DEPARTMENT OF ENVIRONMENTAL MANAGEMENT  
OFFICE OF WATER RESOURCES  
FRESHWATER WETLANDS PROGRAM  
APPROVED WITH CONDITIONS  
AS SPECIFIED IN THE LETTER OF APPROVAL  
DATED MAY 20 2008 FILE # 08-0012  
NO CHANGES ALLOWED WITHOUT PRIOR APPROVAL  
APPROVED PLANS MUST BE AT CONSTRUCTION SITE.

Site Plan  
**Proposed Single-family Dwelling**  
Lot 9  
Hill Road  
Rhode Island  
Prepared for:  
John Rogue  
Burrillville  
345 Thames Street - Unit 201 Bristol, RI 02809  
date: Dec-2007  
scale: As Noted

Design By: REB  
Checked By: BPT  
Sheet  
**1**  
of 2  
FILE NO.: 07.018

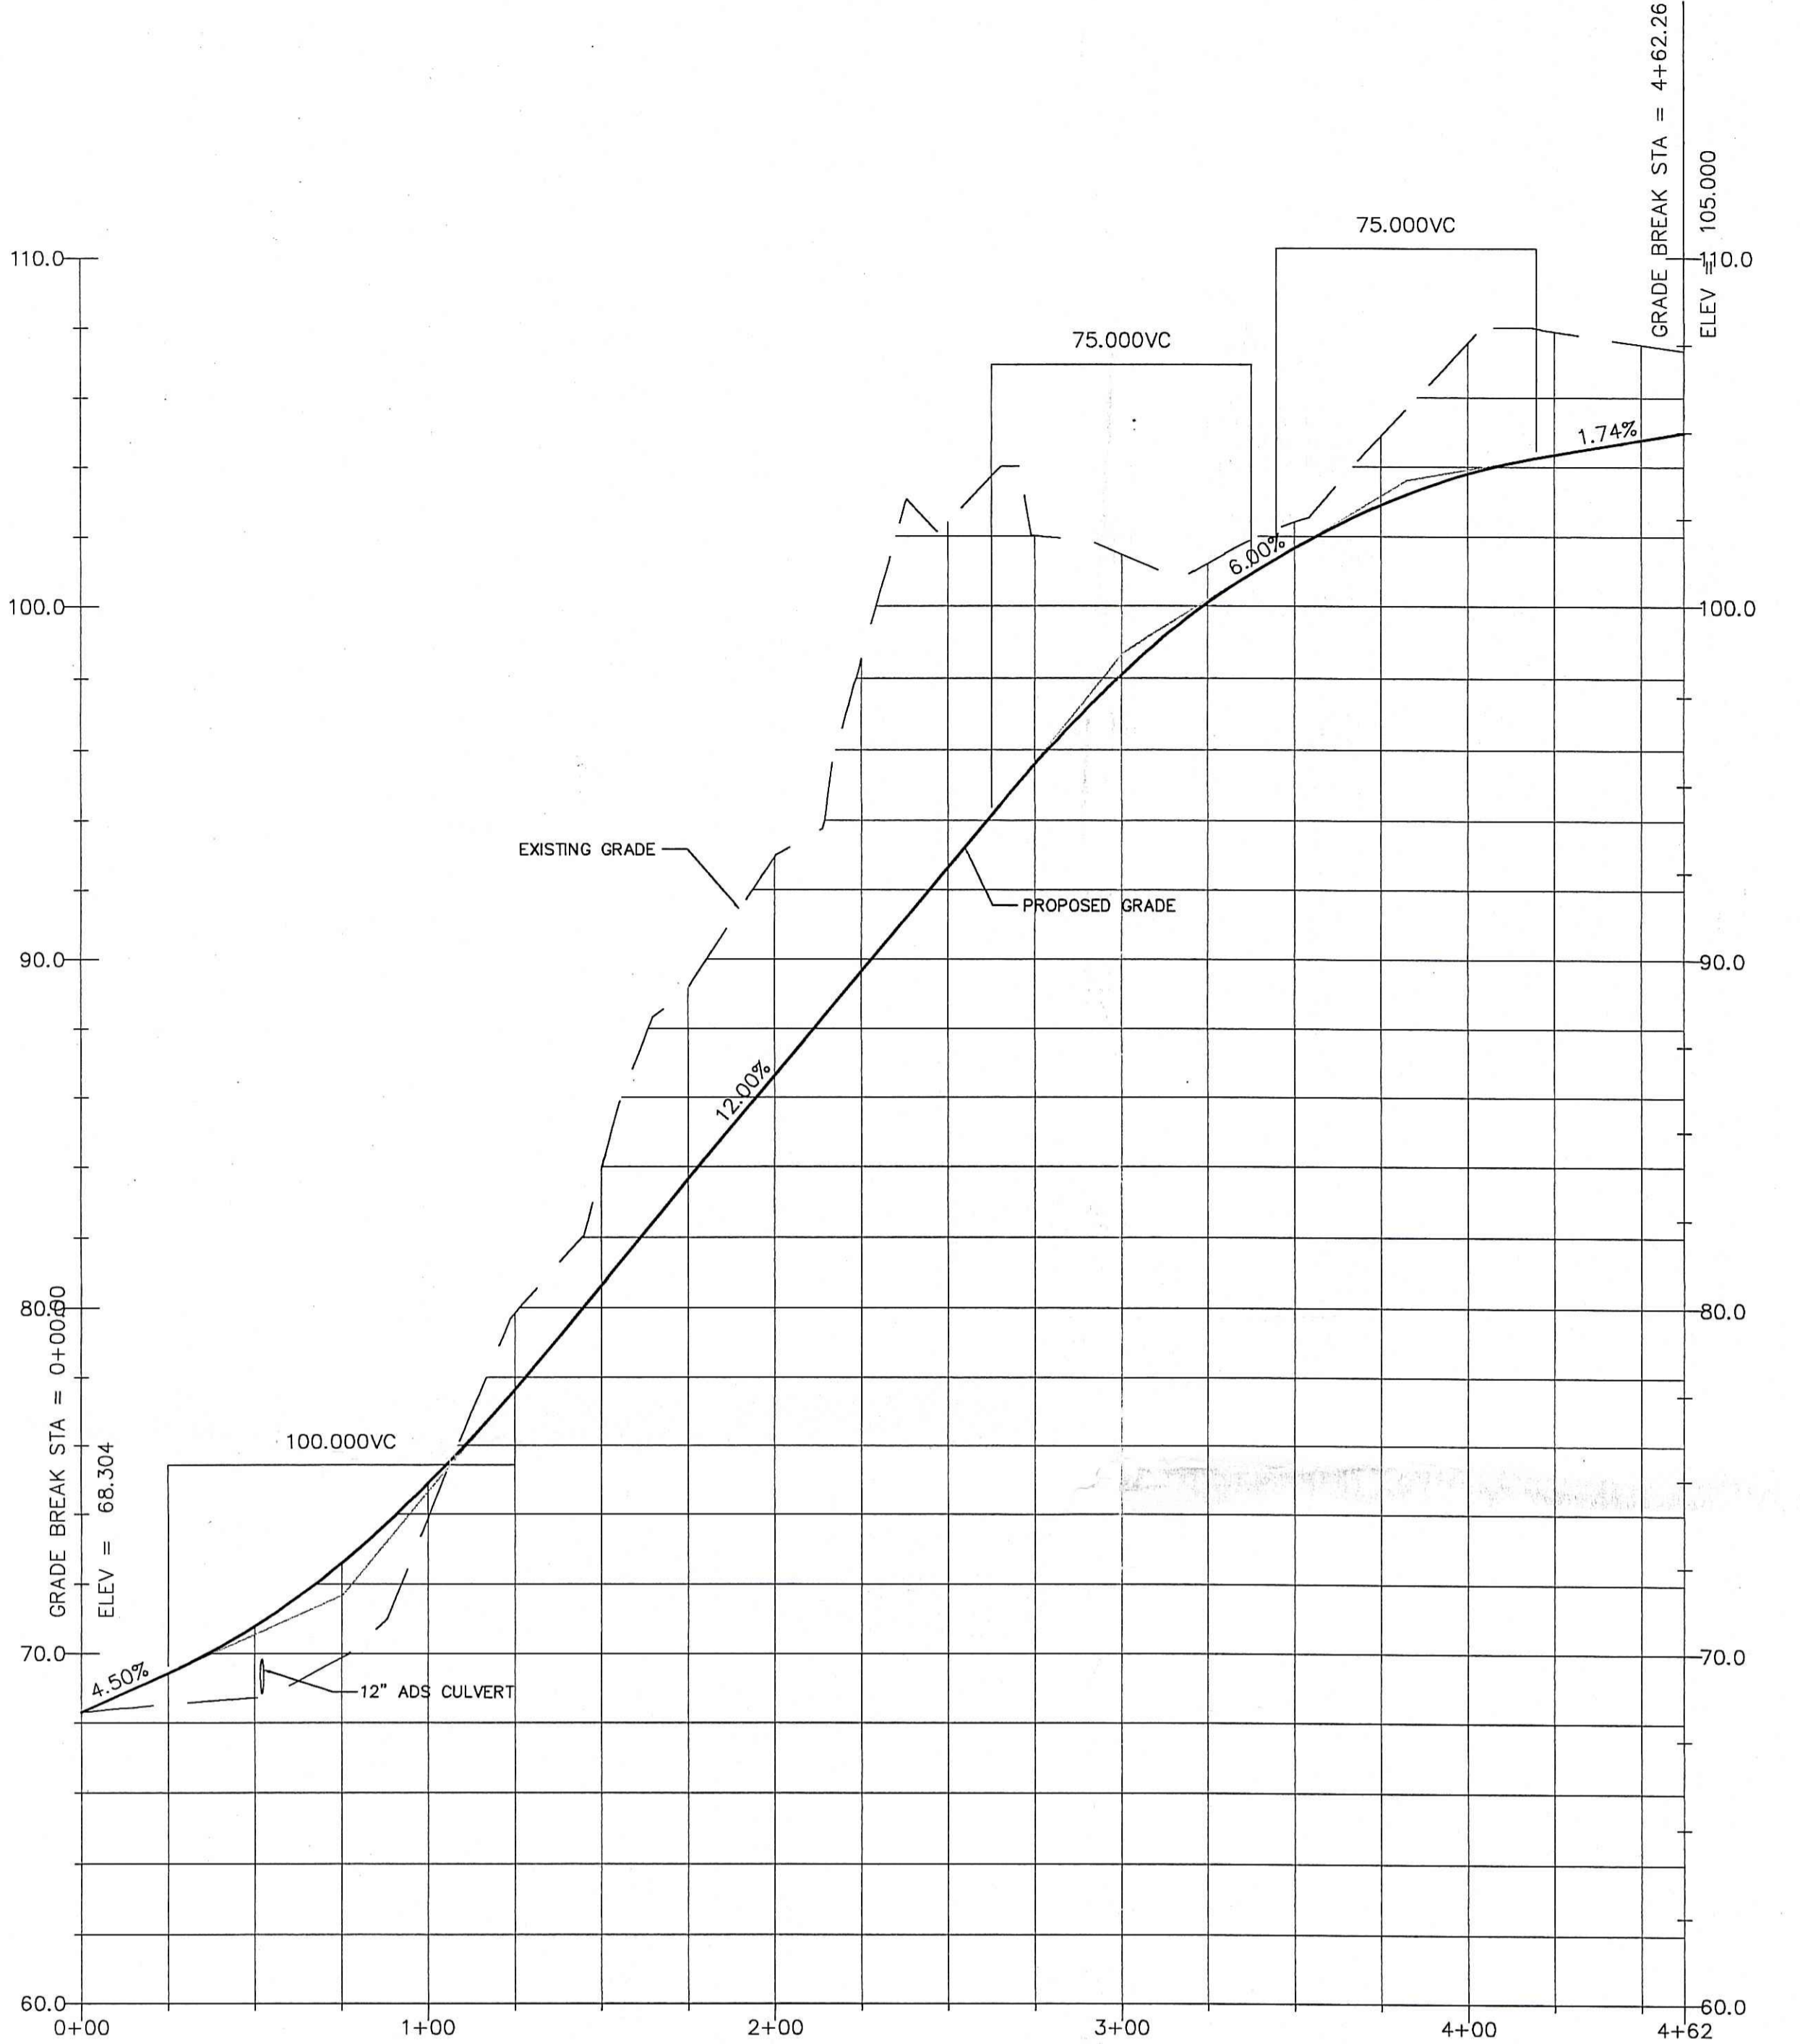
Revised per DEM!  
Relocated silt fence and  
Limits of disturbance.  
Marked area shall remain  
undisturbed to avoid  
wetland area.
